Mandatory Safety Notice SN 2025-01

Subject: Elevator Balance tube removal.
Model Affected: MXS and MX2 Aircraft fitted with adjustable balance tubes.

Elevators resting as one

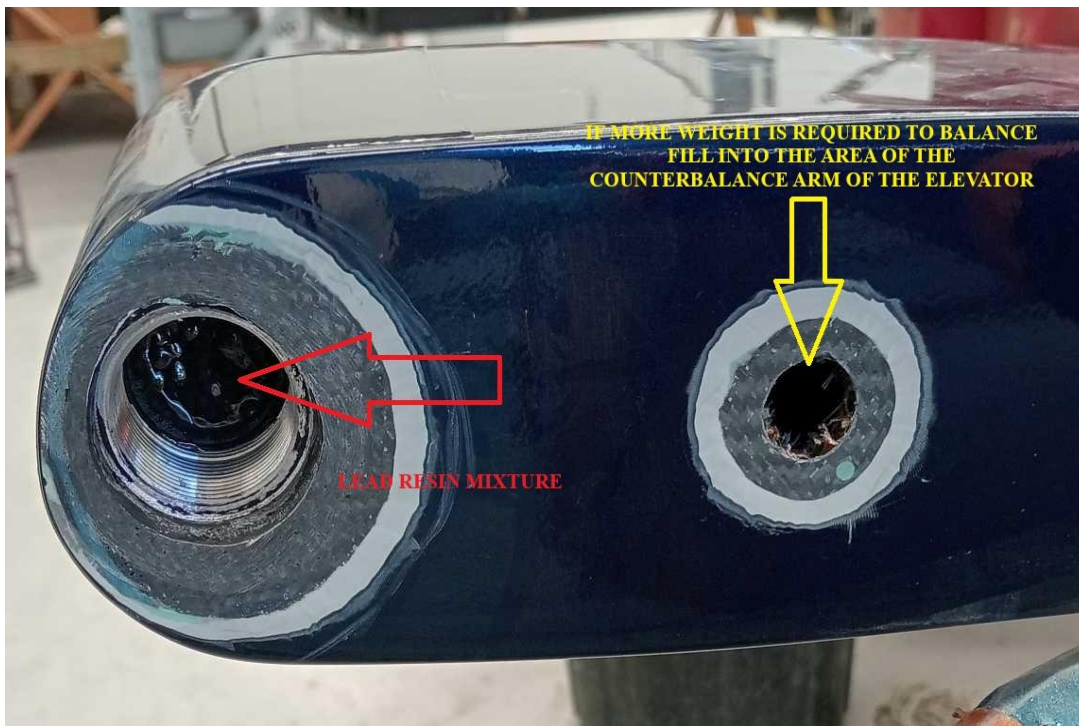
Firstly, remove the elevators from the aircraft. The balance should be conducted with both elevators bolted together acting as one unit. See photo below. Place the elevator onto knife edges and then place a scale as shown below on the trailing edge of the elevator and there should be a weight on the scale from between 0.4kg to 0.65kg. This indicates a trailing edge heavy elevator. If this is not the case balance controls until this is achieved. If weight is required mix a lead shot/resin mixture and pour it into the balance tubes. If more is required, it can be placed into the elevator horns.

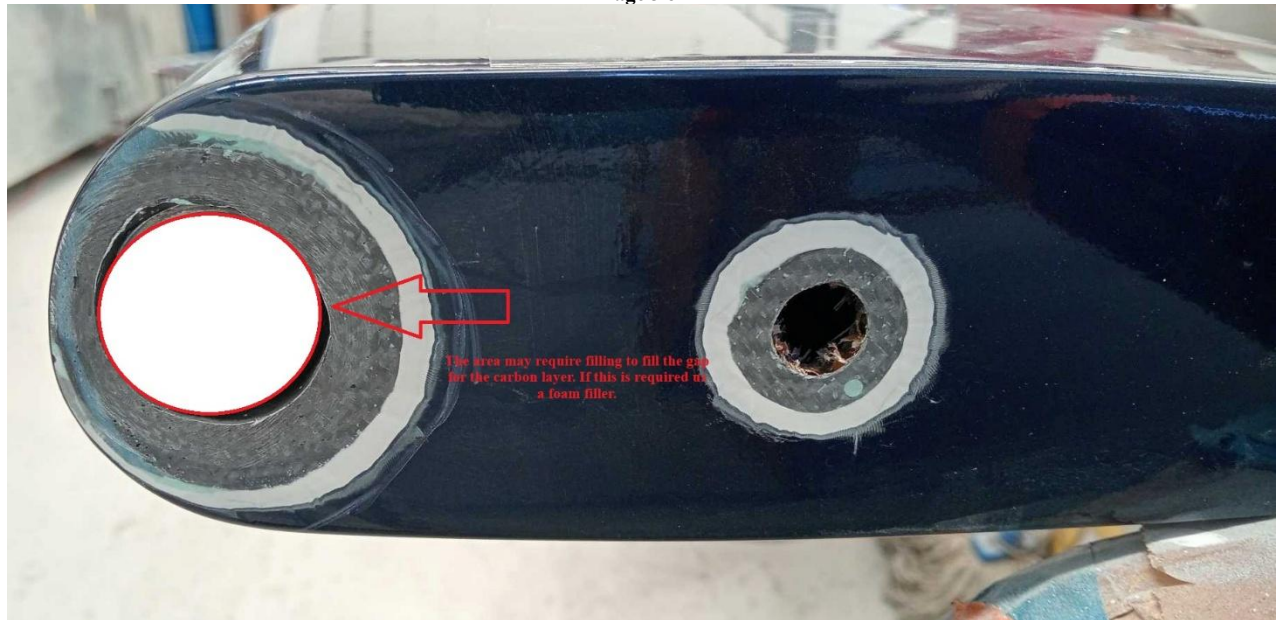
The reference elevator in the image had initially had an exceeding trailing edge heavy weight. Image below shows where the lead/resin mixture was filled. Image also indicated where more weight may go if required.
